# City of Albertville Council Agenda

**SUBJECT: PLANNING – MEDART INDUSTRIAL DEVELOPMENT APPLICATIONS**

**PLANNING REPORT**

**SITE PLAN**

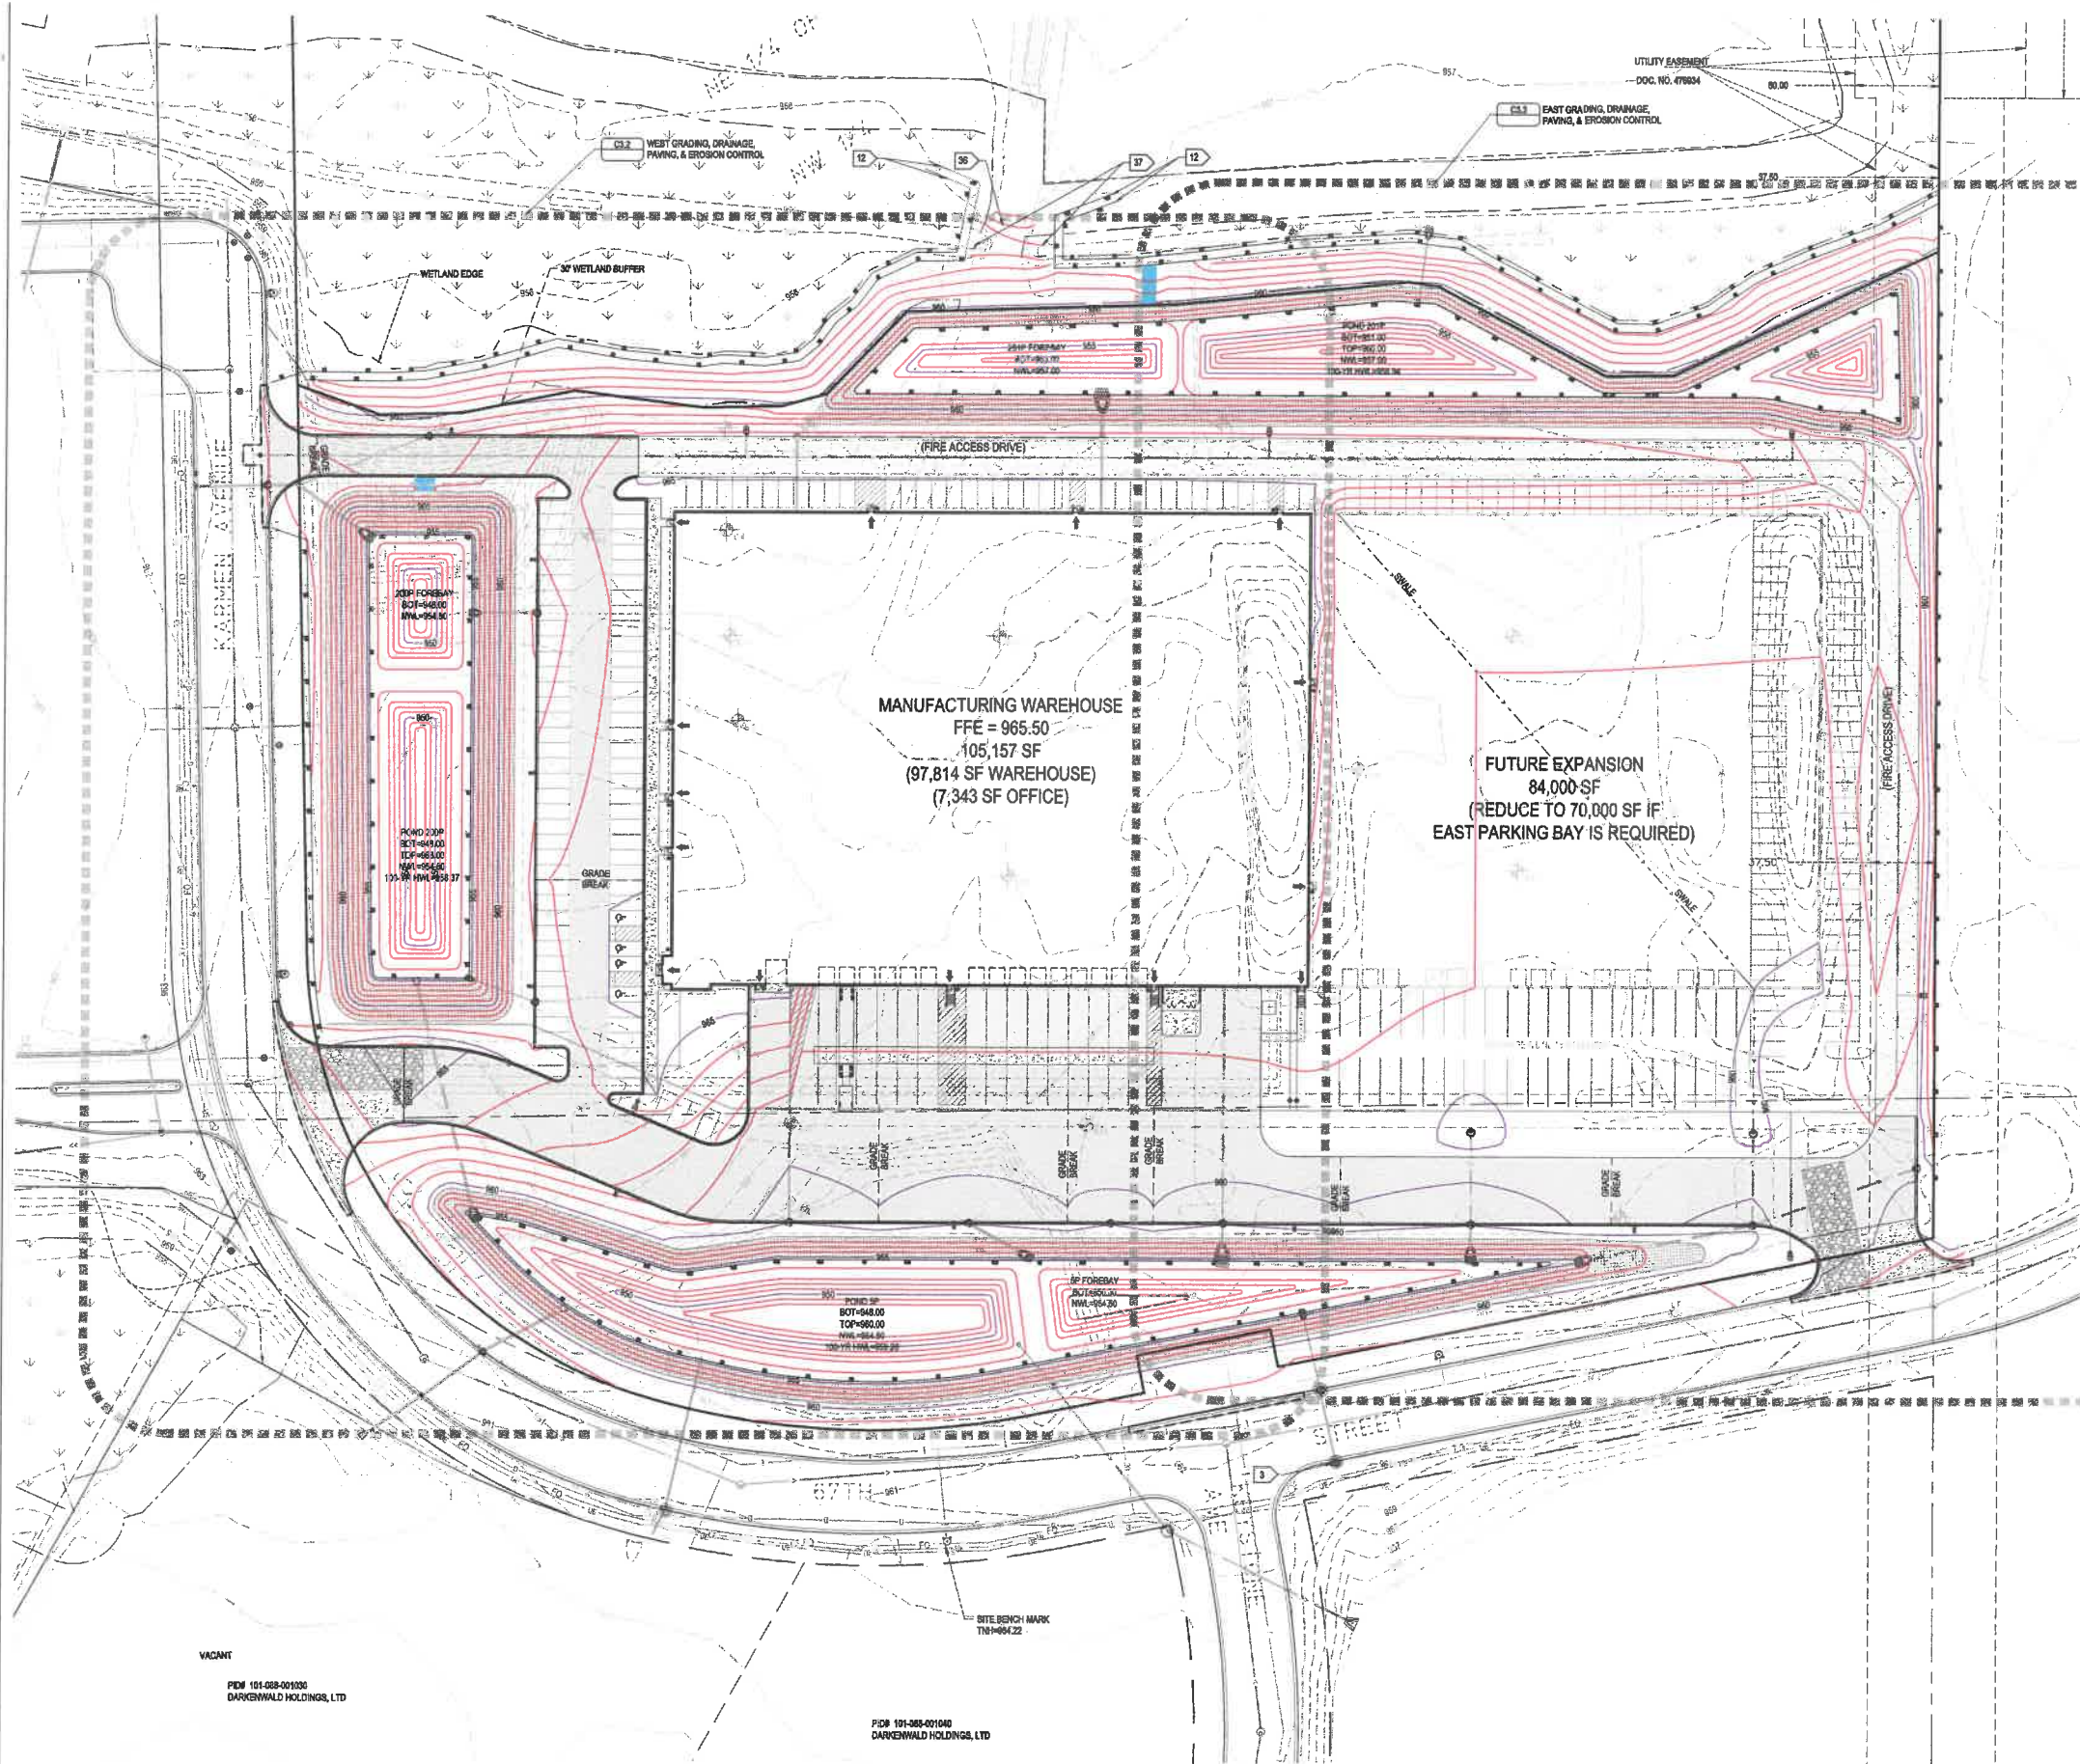
Lot Coverage. Within the I-2 zoning district lot hard coverage is limited to 85% of the total lot area. The site plan indicates that the proposed phase building and parking will cover 57.9 % of the total lot area.

1. The proposed site plan shows three curb cuts serving the site. The site size and street frontage allow this number of curb cuts.
2. The proposed southern curb cuts at south and west property lines measure 62 and 65 feet in width. By City Code the maximum curb cut width is 24 feet unless otherwise approved by the City Engineer. The City Engineer will review the proposed curb cuts and provide a recommendation for an acceptable curb cut width as a PUD flexibility.

3. The site plan design segregates the automobile parking from the loading area.
4. By code all drive aisles are required to be paved with bitumen or concrete. The applicant is proposing a 24 foot drive aisle around the building with a gravel surface. This drive aisle will serve as a fire lane around the building and will be improved with the future building addition or if additional parking is required. The City may allow a temporary exemption for paving this drive aisle through PUD flexibility provided the gravel drive aisle is designed to meet the 2020 Minnesota State Fire Code, Fire Apparatus Access Road for all-weather access. Staff, also recommends that this drive aisle be improved to a paved surface by October 2030 or with the future building addition whichever is sooner.

The site plan illustrates 73 improved parking stalls and 141 proof of parking stalls, 214 total stalls. The phase 1 development parking count is below the required parking count of 121. The improved parking count is reflective of the company anticipate employee count. Proof of parking demonstrates that the site can provide adequate parking. The proof of parking is recommended to be approved as part of the PUD with the following conditions.

Disability parking stalls. The site plan shows 4 disability parking stalls within the west parking lot. These disability parking stalls are adequate for the 73 stalls. As additional stalls are built the number of disability stalls must be increased. The site plan shows a total of 214 parking stalls this will require 6 disability stalls. The site plan must show the location and design of the 6 disability stalls.

Loading: The site plan illustrates 16 loading berths on the initial phase one building and 15 loading berths on the future building addition. In review of the site plan, we offer the following comments.

Trash Handling. The site plan shows the location of an outdoor trash enclosure on the south side of the building. Exterior trash enclosures are to be designed to match the building. Applicant shall provide a detail of the side walls and gates showing materials and design.

Building Layout. The building has man door exiting on all sides of the building. Doors on the west and south sides of the building exit onto a sidewalk or into the paved loading area. Doors on the north and east side of the building must provide landing and sidewalks to exit and move away from the building. These landings and sidewalks must be kept clear of obstructions and snow. The site plan must show how exiting, and sidewalks will be established for the doors on the north and east sides of the building.

2. The site plan be revised to implement the City Engineer's recommendation for curb cut widths for the site.
3. The City approves PUD flexibility for a gravel fire lane around the north and east side of the building per the approved site plan. The gravel drive aisle shall be designed to meet the 2020 Minnesota State Fire Code, Fire Apparatus Access Road for all-weather access. The gravel fire land shall be improved to a paved surface by October of 2030 or with the future building addition whichever is sooner.

- All parking shall be designed and constructed to meet City parking standards.
  - The site plan shows a total of 214 parking stalls this requires 6 disability stalls. The site plan must be revised to show the location and design of the 6 disability stalls.

5. The Applicant shall provide a design detail of the proposed trash enclosure showing the exterior materials of the enclosure and gate.
6. The site and landscape plan must be revised to show landings and sidewalks for the doors on the north and east sides of the building. These landings and clear paths shall be kept clear of obstructions and snow from the doors to a drive aisle.

**BUILDING ELEVATIONS**

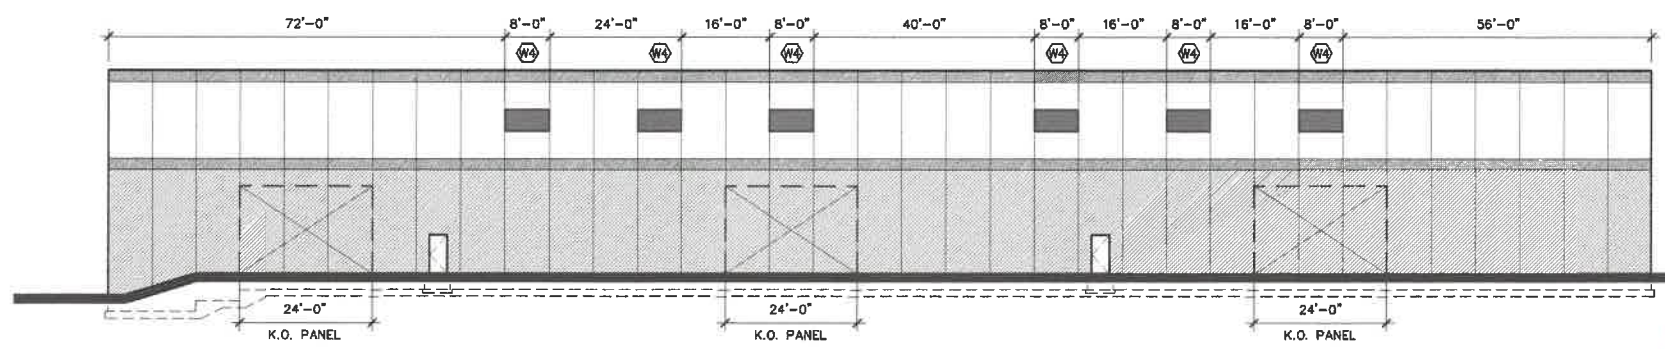
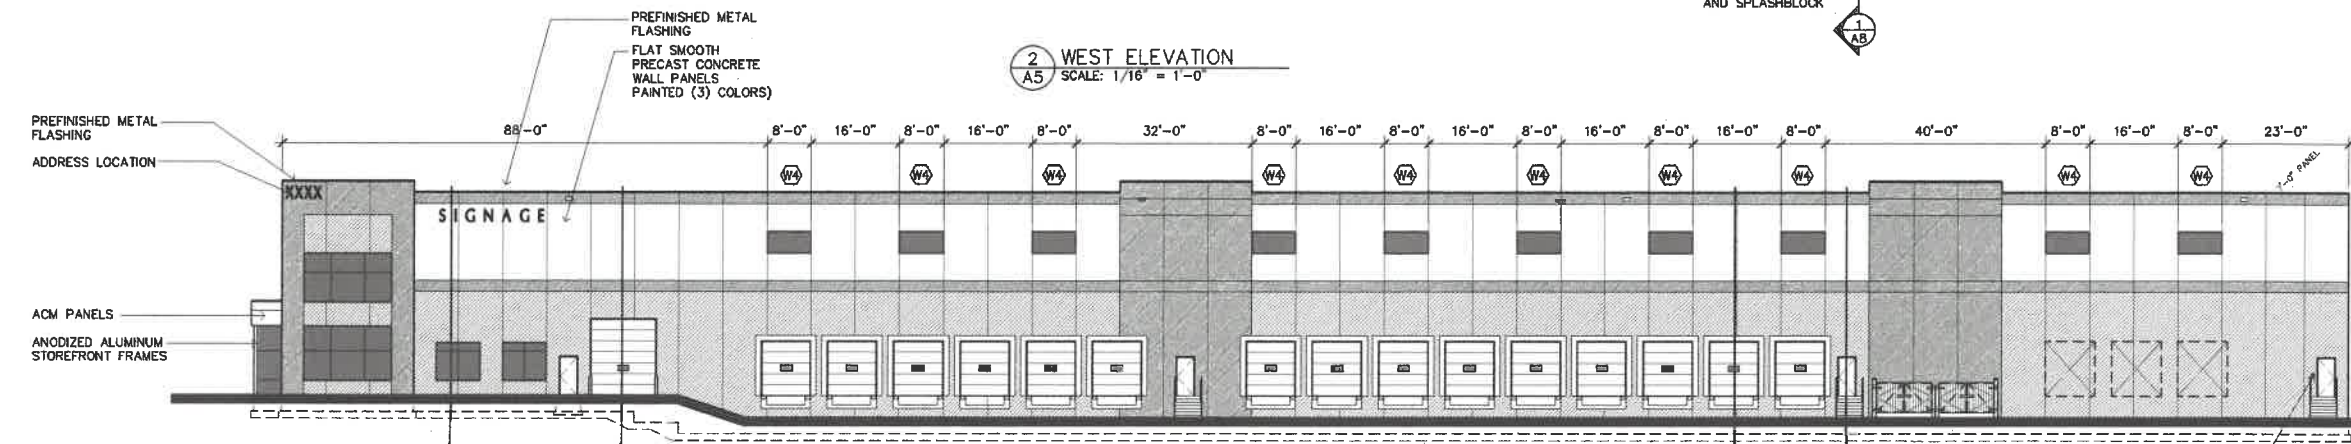
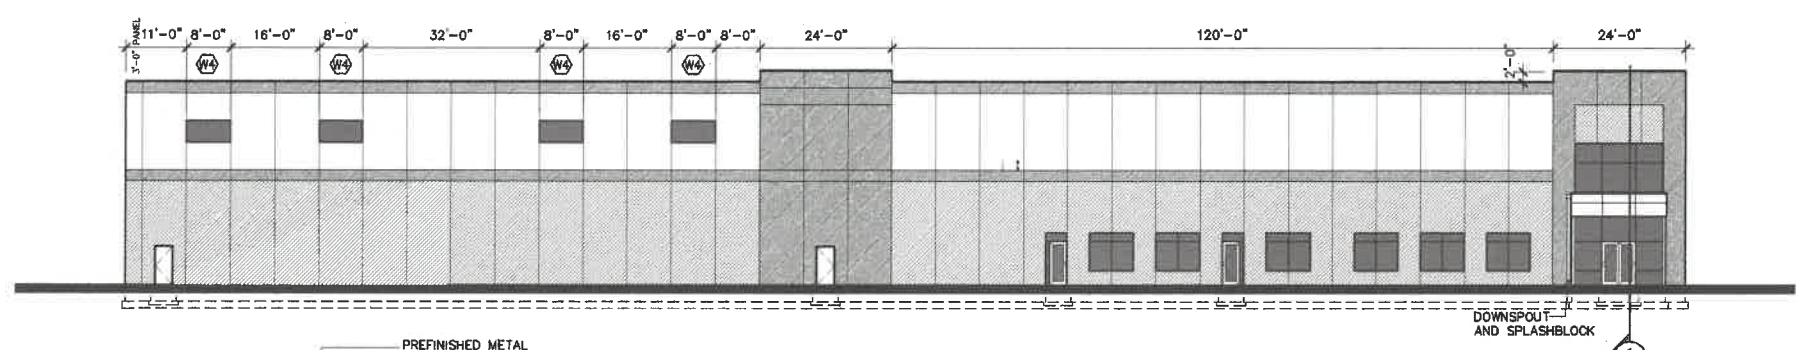
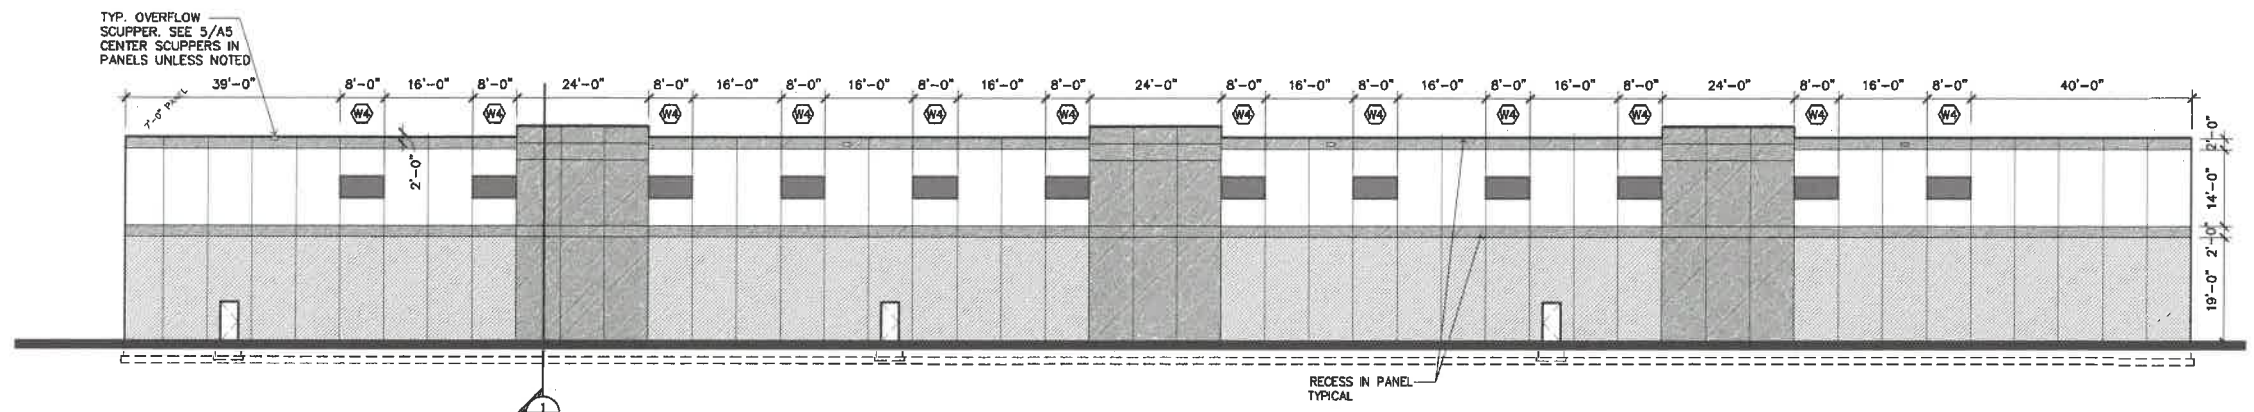
Building Materials. The Building Elevations show the exterior building treatments for each of the buildings. The building will be constructed of precast concrete panels painted with three colors. The building materials meet the I-2 district standards.

Signage. The building elevations show wall signs on the south side of the building. A separate sign permit shall be required with the submission of the building permit. The sign permit shall address the following details.

1. The wall sign details showing the sign size and location. Within the I-2 district wall may be permitted on walls facing a public street. The wall signs size may be 10% of the wall area or 200 feet whichever is less.
2. If a freestanding sign is proposed the plan must identify the sign's location and design. Within the I-2 district ground signs shall not exceed 200 sq. ft. in area or 30 feet in height.
3. If directional signs are proposed to direct traffic or on-site operations, a comprehensive sign plan can be approved for the site. The comprehensive sign plan must identify the number, size and locations of proposed directional signs. Traffic control or directional sign shall not exceed 4 sq. ft. in area.
